PedalPCB.com

Wrectifier PCB

Vintage/Modern Switch Modification

Revision 12.06.17

Back of PCB

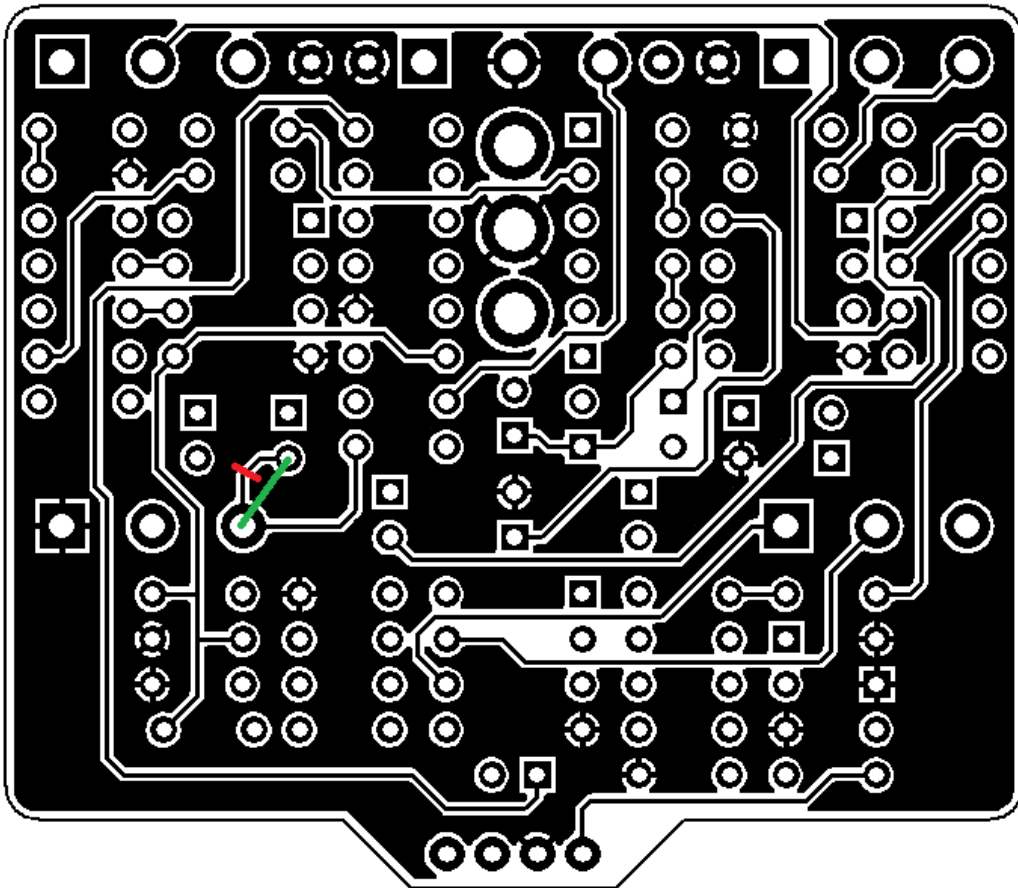
- 1) Cut PCB trace at point marked in **Red**
- 2) Solder 10K resistor across points marked with **Green** line
